DOE/RL-93-73
Revision 1

300 Area Process Trenches Modified Closure/Postclosure Plan

ADDENDUM

**300-FF-1 PROPOSED PLAN DISCUSSIONS AND EFFECTS ON THE 300-FF-1 PHASE III
FEASIBILITY STUDY AND 300 AREA PROCESS TRENCHES MODIFIED
CLOSURE/POSTCLOSURE PLAN**

Figure AD-1. Cobalt-60 Countour Map of South Process Pond.

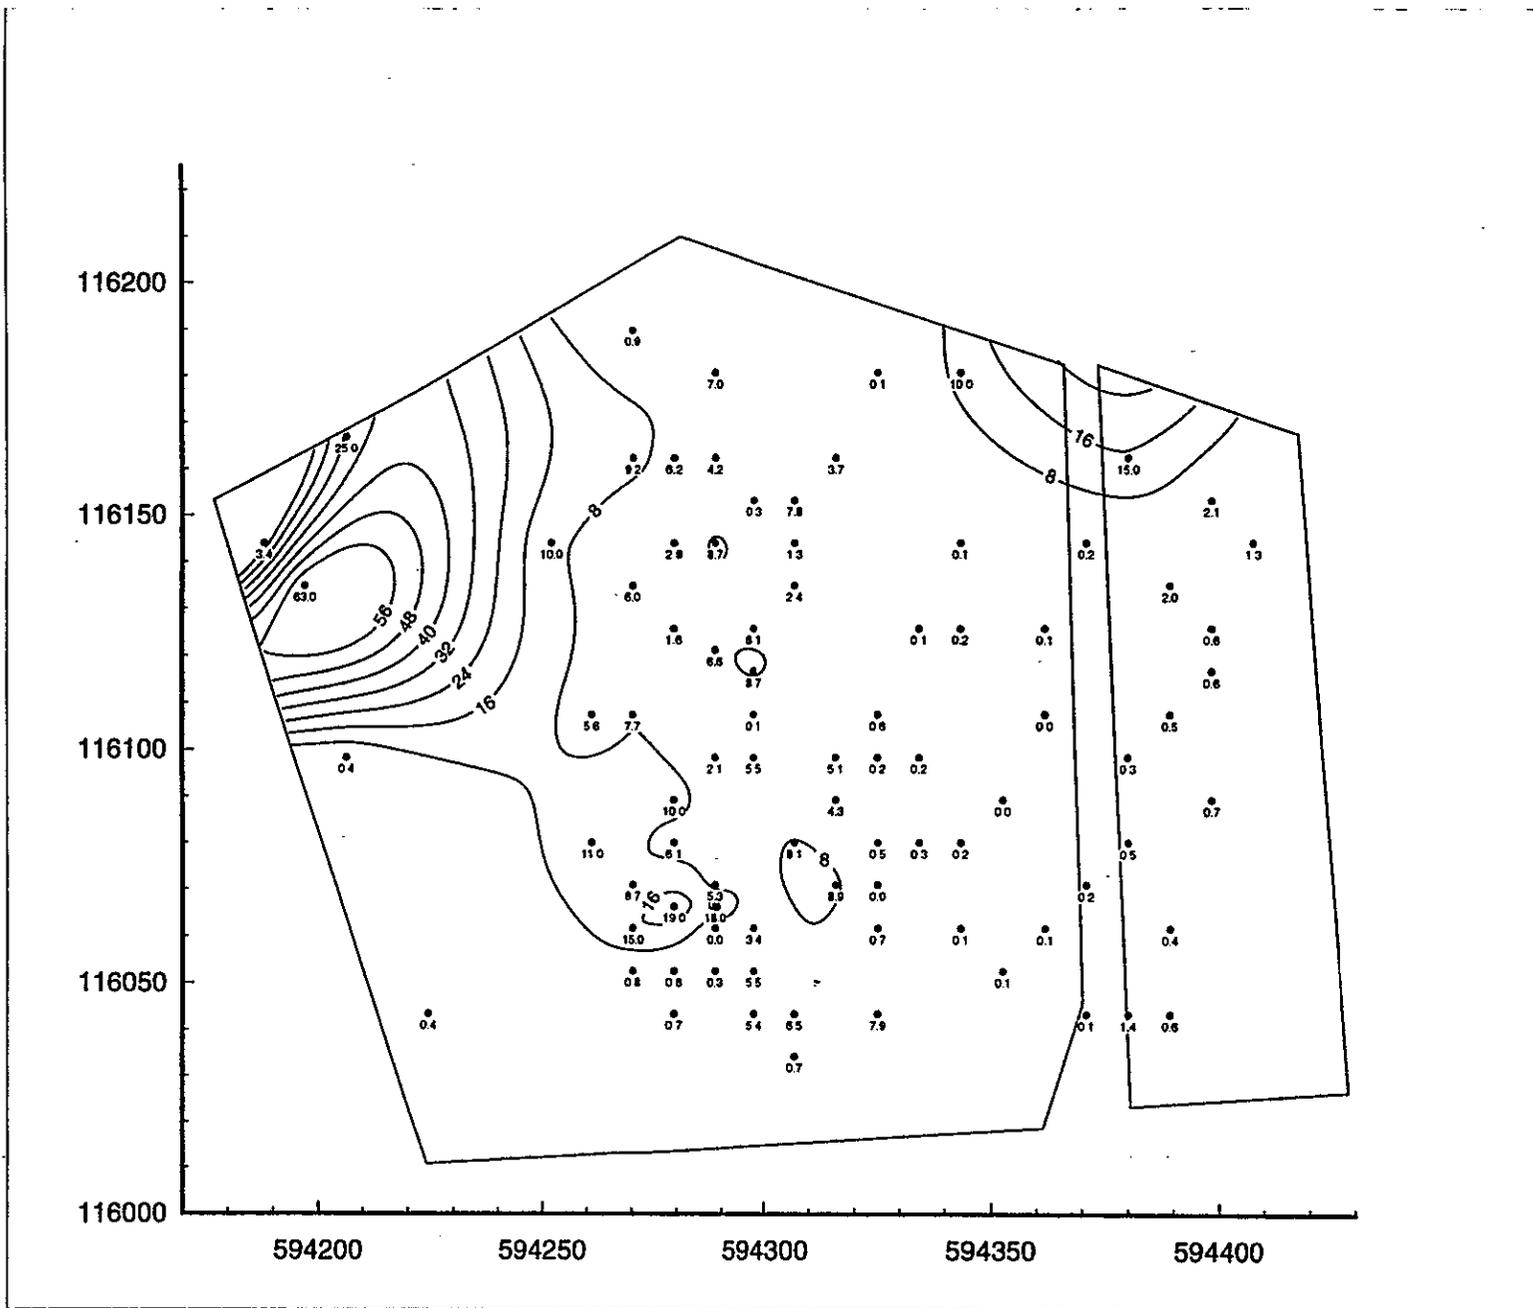
Cobalt-60 sampling results during the RI/FS show that there is a present risk in the South Process Pond. The potential increase in cancer risks is 2×10^{-4} due to external exposure. The risk is determined from limited data. During evaluation and selection of the proposed preferred alternative, the questions arose of how much remediation should be completed based on cobalt-60.

1 Because the risk was driven by only one value, it was decided to conduct additional field screening to
2 confirm the concentration of cobalt-60. The field screening data confirmed that the average
3 concentrations were approximate 5.0 pCi/g, which is shown in the RI/FS. Figure AD-1 show that
4 higher concentrations are limited to several hot spots. These hot spots coincide with uranium hot
5 spots and will be removed when the uranium is removed.

Figure AD-2. Alternative P-3 Process Waste Cleanup Zones.

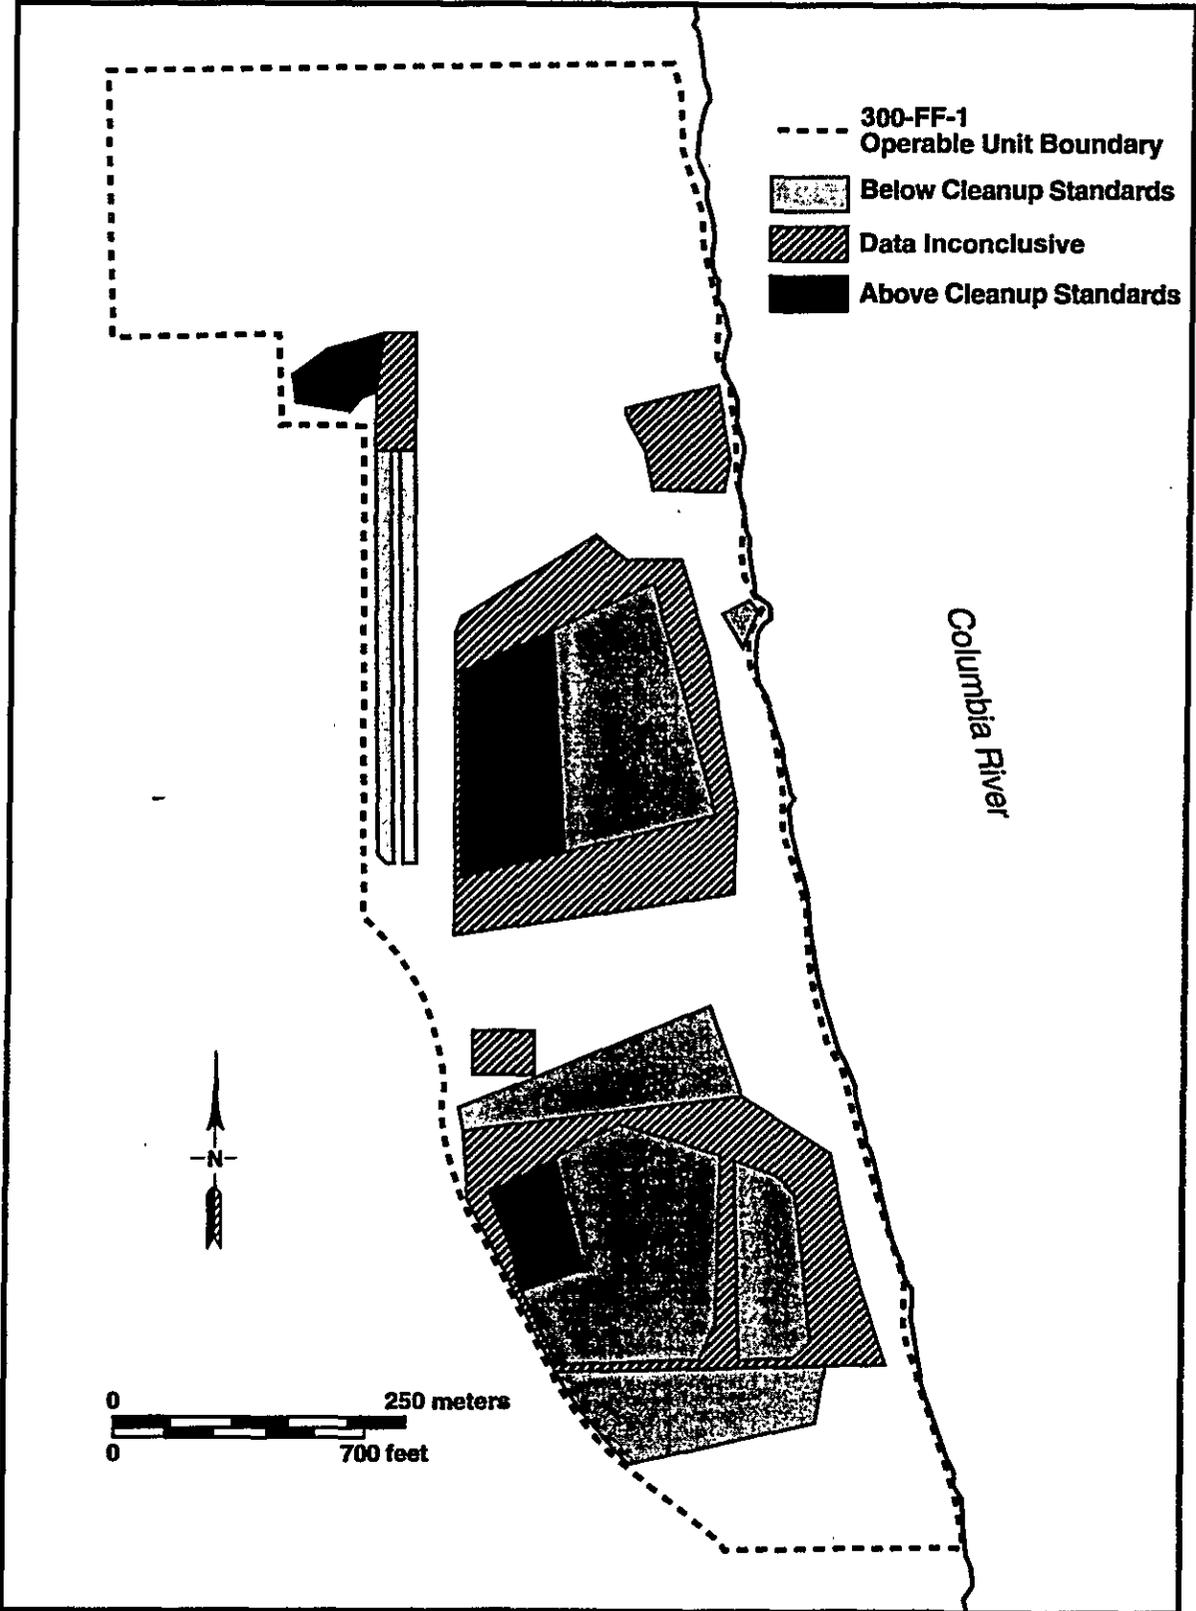
42
43 The original P-3 Selective Excavation and Disposal alternative removes all contamination above
44 PRGs. In the new alternative, the process waste units are now separated into three zones. The first
45 zone contains soils above cleanup levels that would be excavated and disposed. The second zone soils
46 are below cleanup levels and would be left in place without a soil cover. The third zone sampling
47 results are inconclusive, and field screening will be used to determine if soils will be disposed or left
48 in place without a soil cover. The three zones are shown in Figure AD-2.

3 This alternative requires removal of contaminated soil/debris with concentrations above
4 cleanup standards. The individual process waste units can be divided into three zones:
5 areas where the data shows that the soil is above the cleanup standard, areas where the
6 data shows the soil is below cleanup standards, and areas where the data is inconclusive.
7 The locations of these three zones within the process waste units are shown on
8 Figure AD-2. Under this alternative, soil would be removed from the areas where it is
9 known that the soil is contaminated (above the cleanup standards) with little sampling
10 and analysis except for confirming all contaminated soil had been removed. Areas that
11 are already below the cleanup standard would be left in place. The areas where the data
12 is inconclusive would require field analyses to determine if the soil was contaminated
13 above the cleanup standards or not and therefore would be removed or not. Excavated
